COMMUNITY MASTER PLAN

LEVEL B PLAN: AS APPROVED BY DEVELOPMENT REVIEW BOARD FEBRUARY 2008

AMENDED FEBRUARY 2024

Mesa del Sol

Figure 4-4

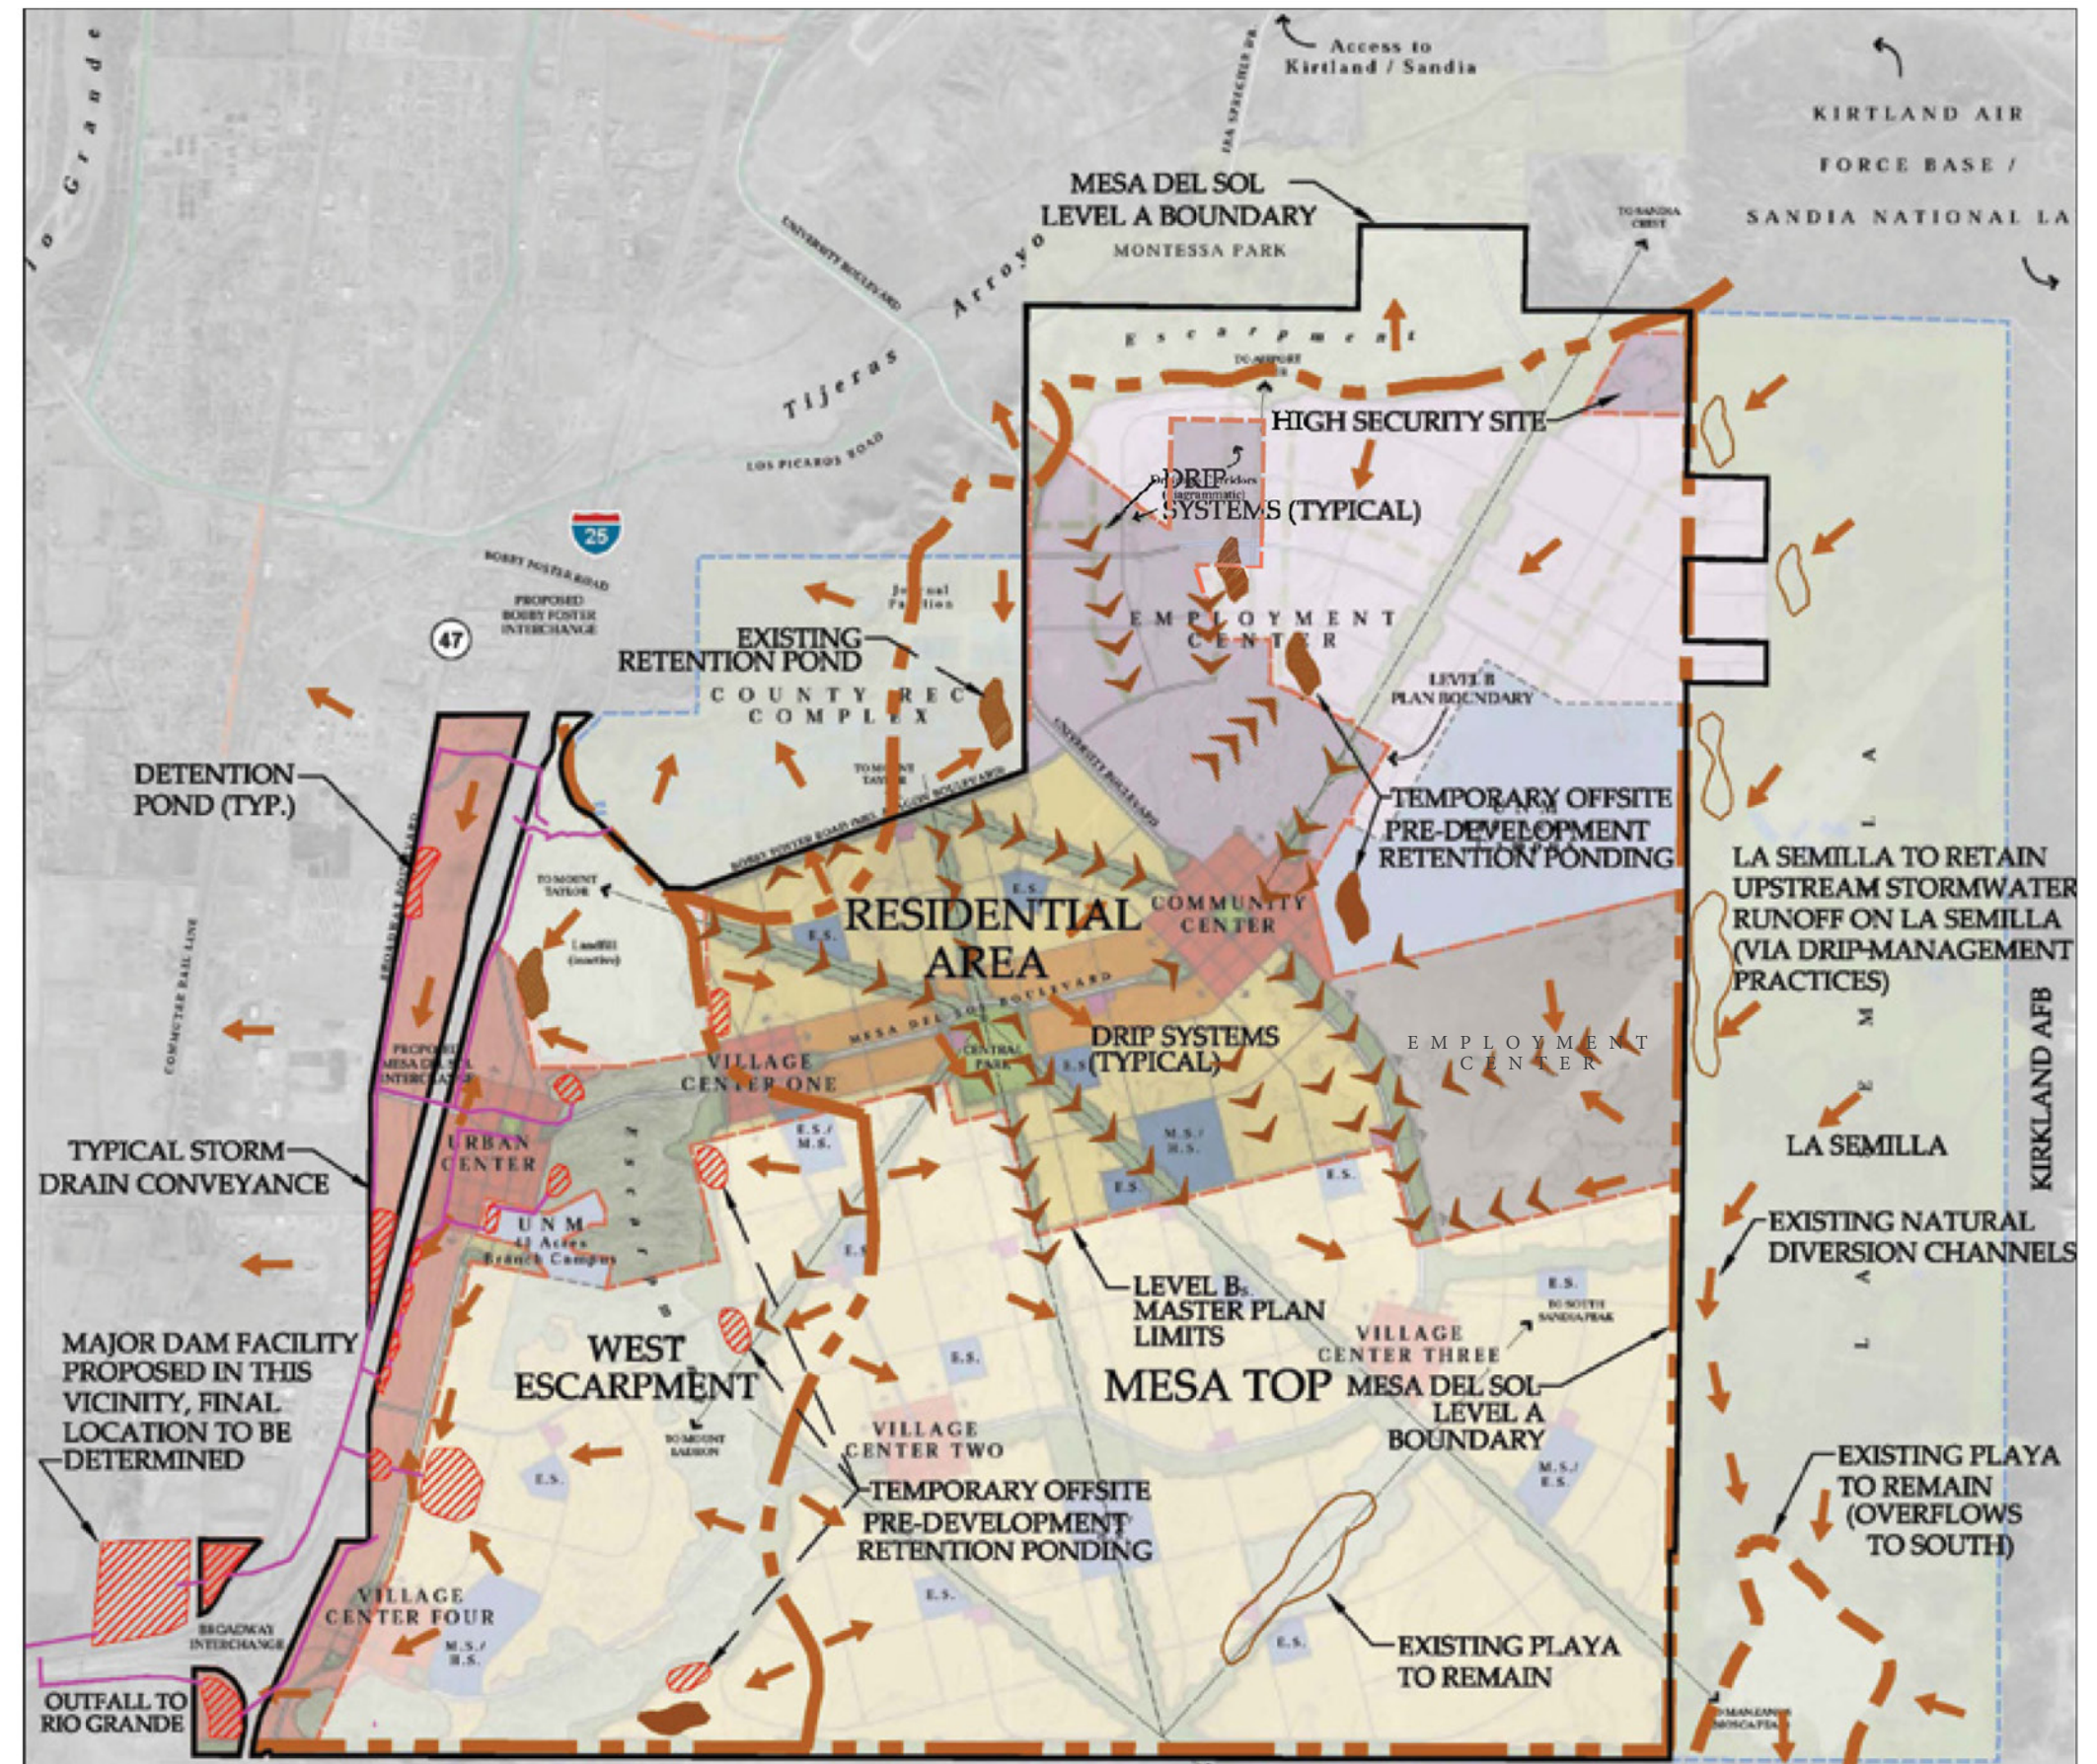
- Figure 3-6 updated Pedestrian and Bicycle Circulation to remove roadways, bike lanes and linear park / drainage corridors.
- Figure 4-4 updated Overall Stormwater Plan with revised approach for project area including remove/re-route DRIP system and ID pond location(s).

- Figure 4-4 base map was updated to reflect employment rather than residential
- Section 4.5.2 revised acreages to reflect usage change
- Figure 5-1 base map was updated to reflect employment rather than residential

Figure 5-1

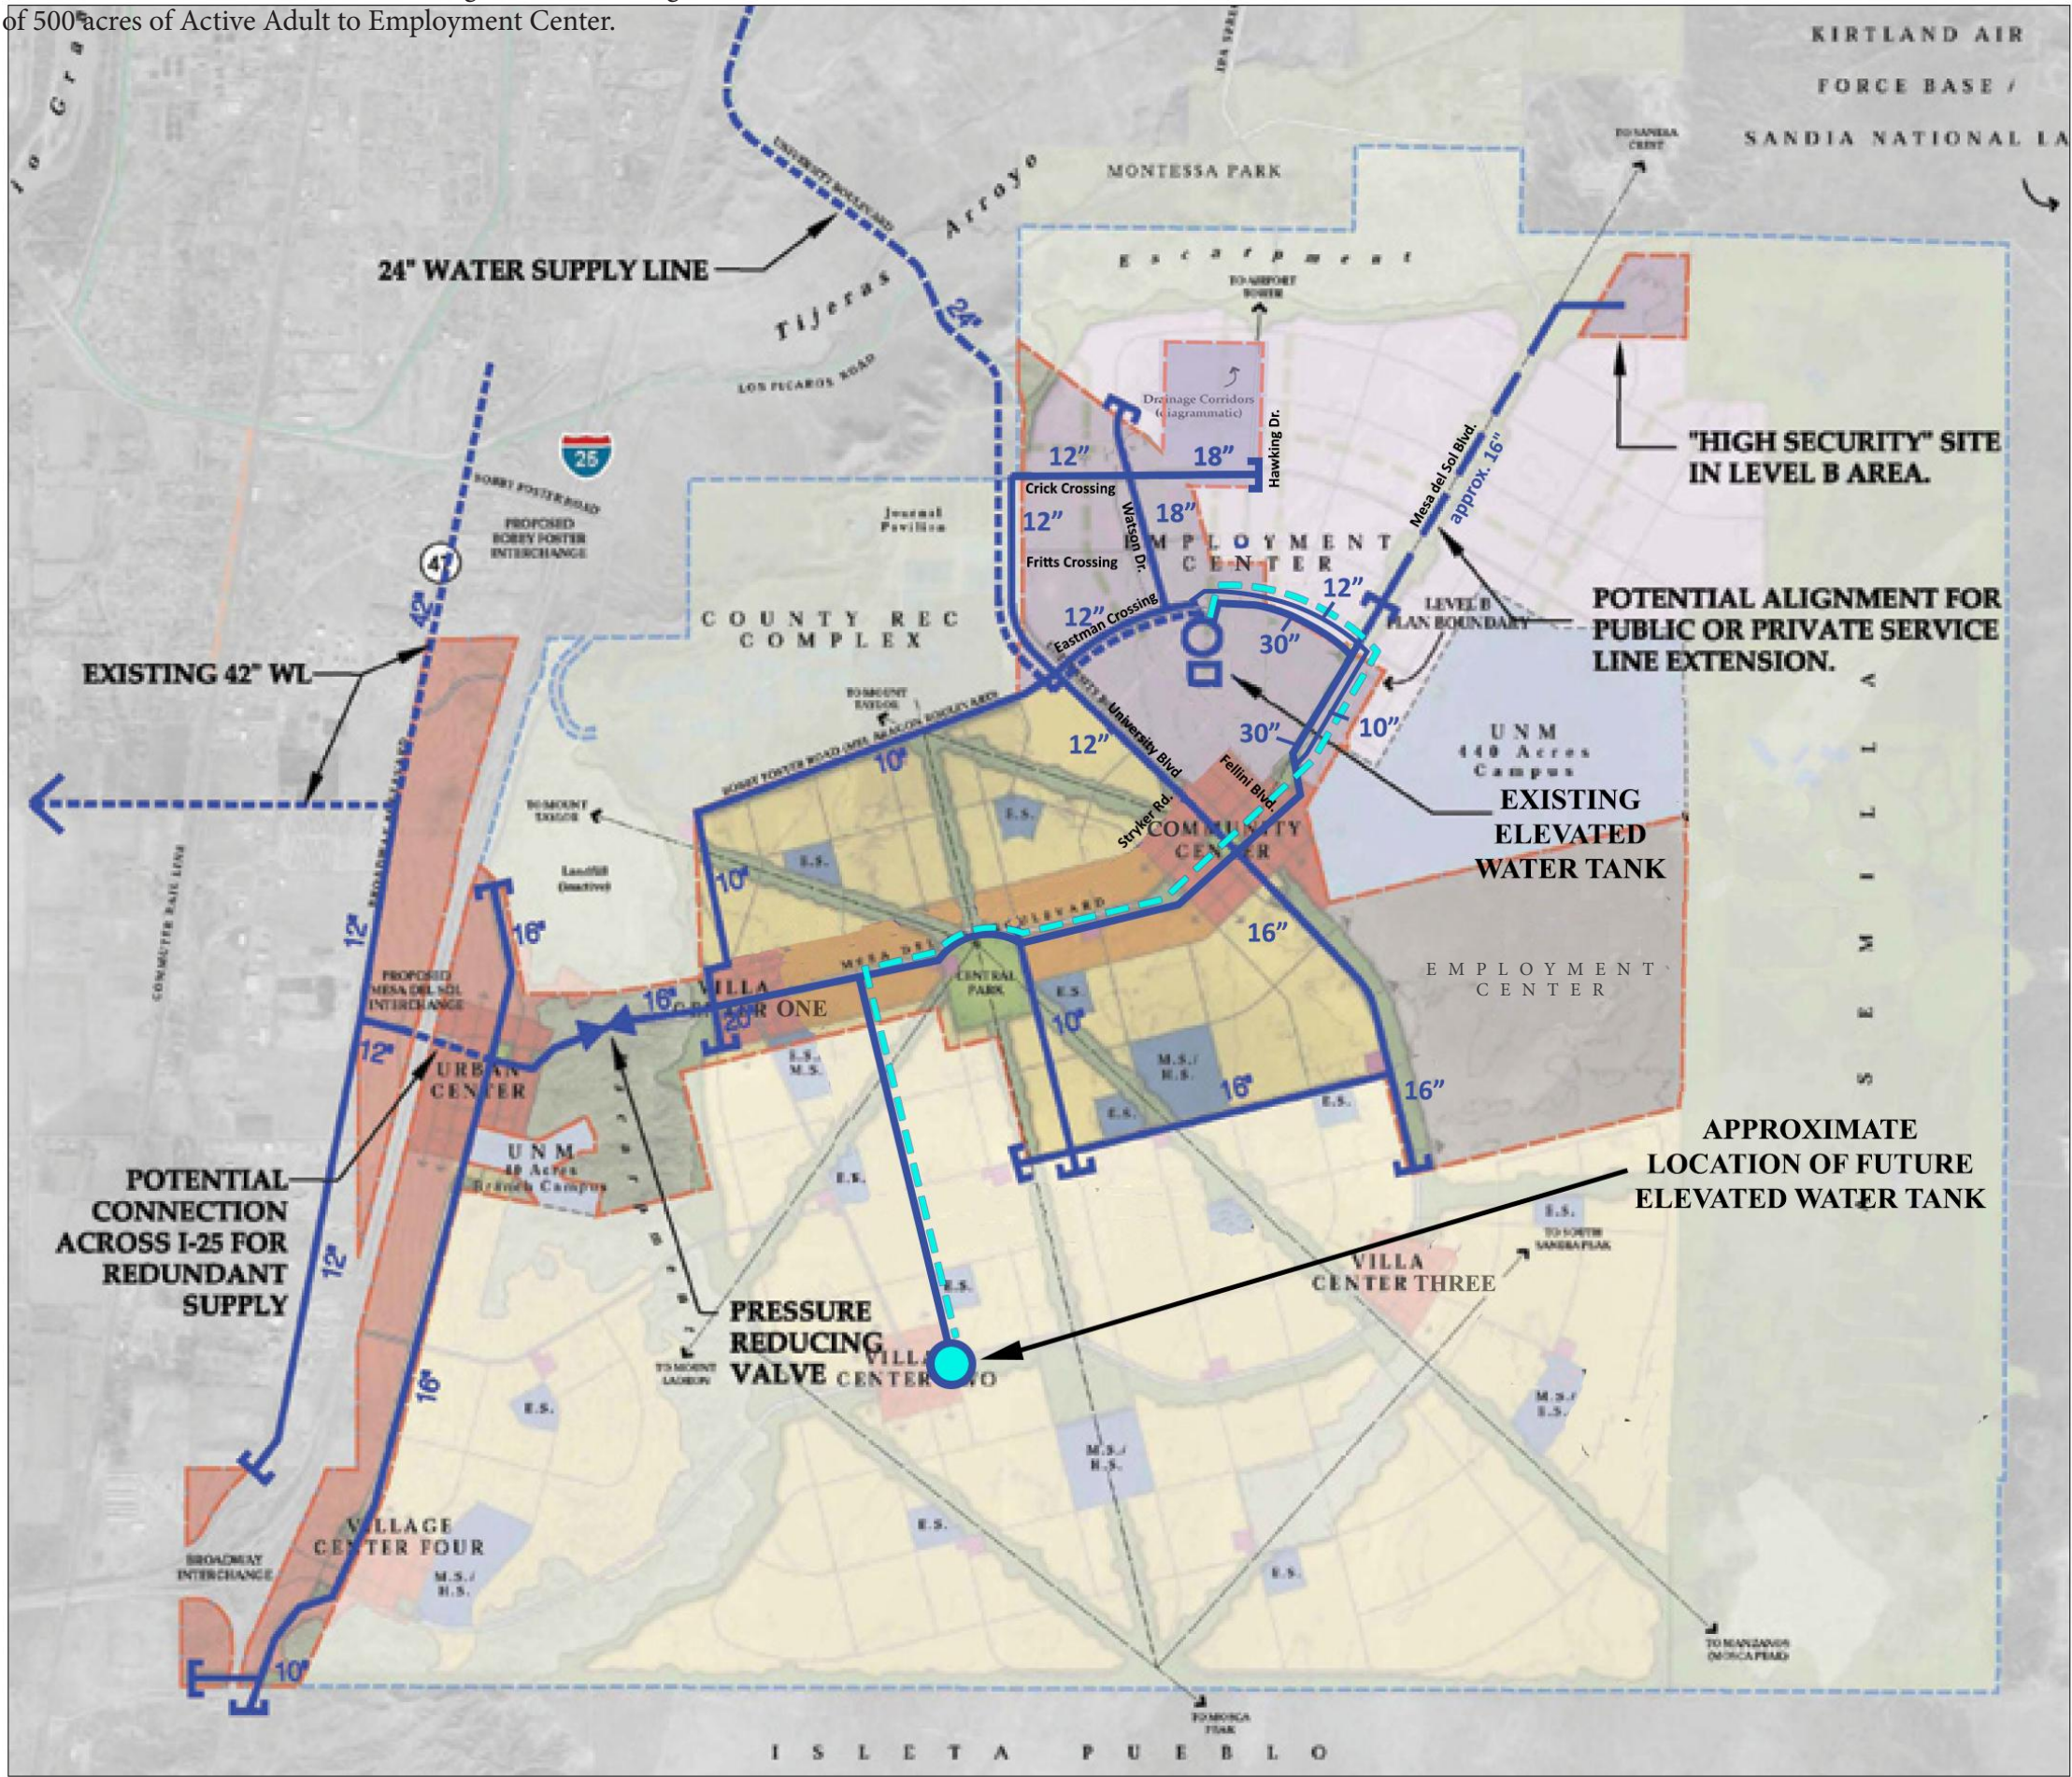
- Figure 5-1 updated Trunk Water System Infrastructure Plan to accommodate re-routes in and around project area and reconcile pipe sizes.
- Figure 5-2 updated Trunk Sanitary Sewer Master Plan to accommodate re-routes in and around project area; ID lift station needs

Figure 5-2

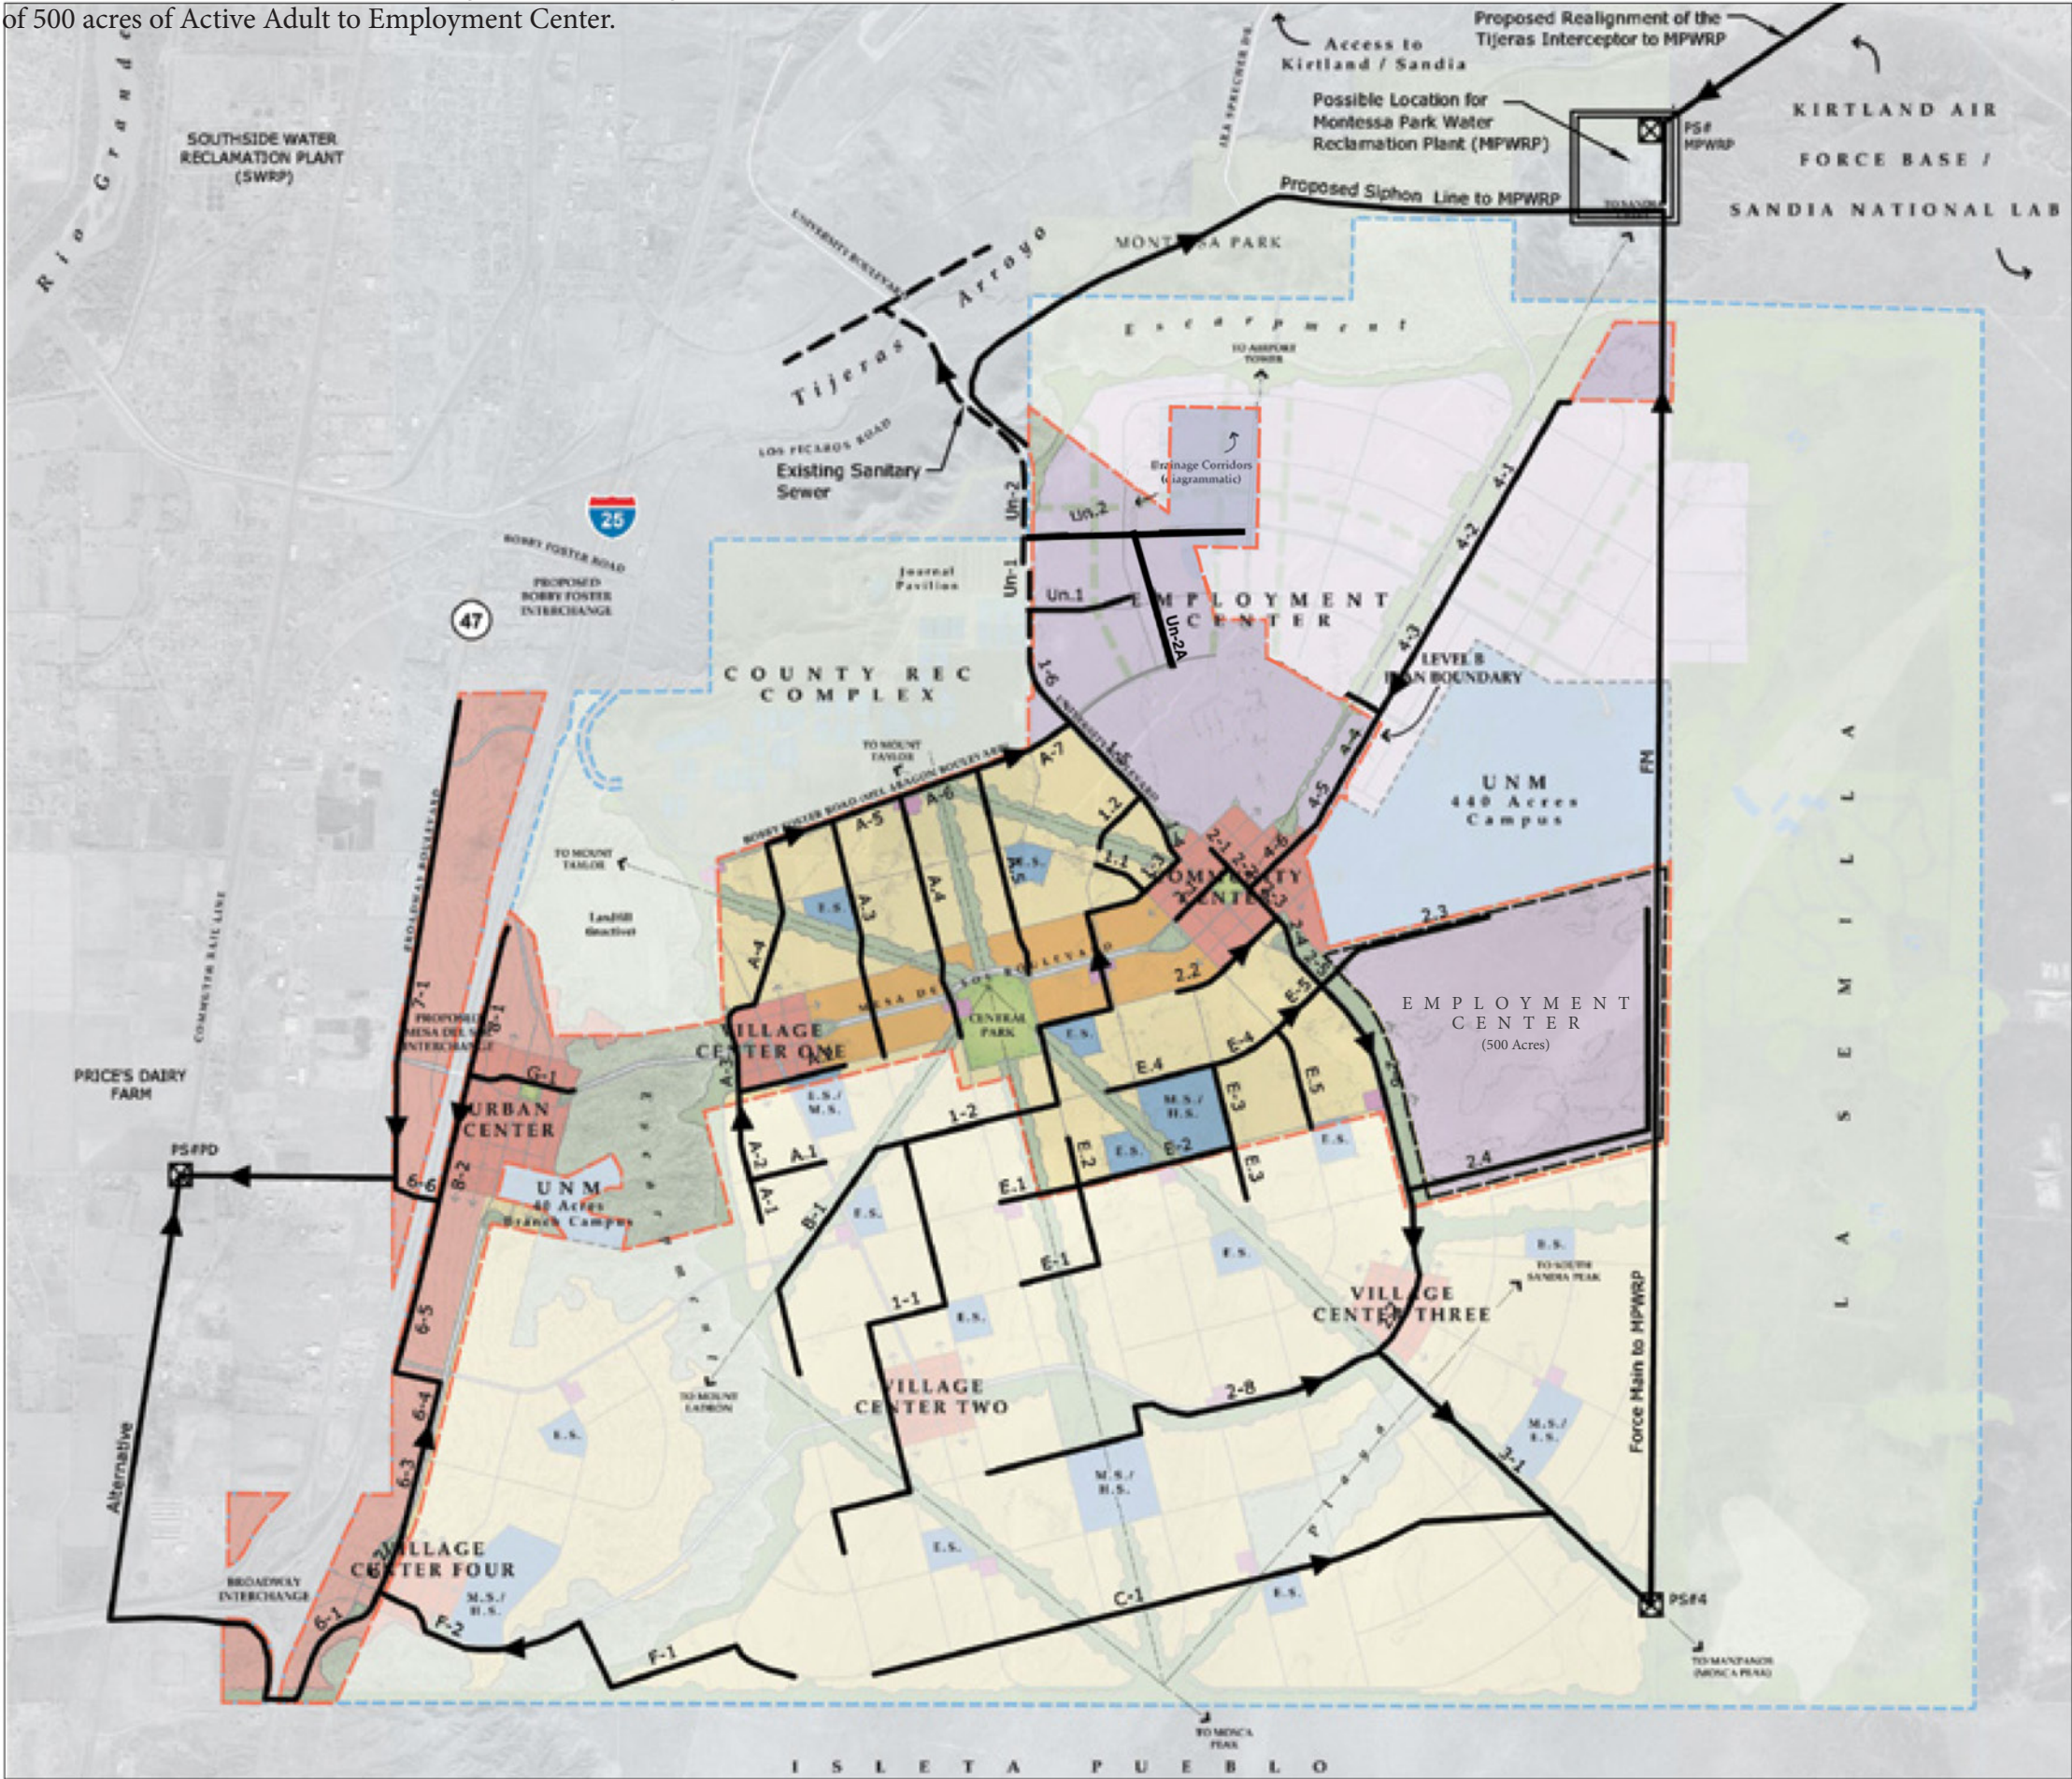
- Section 5.2.1 was updated to remove text reference to ‘senior community area’
- Figure 5-2 base map was updated to reflect employment rather than residential
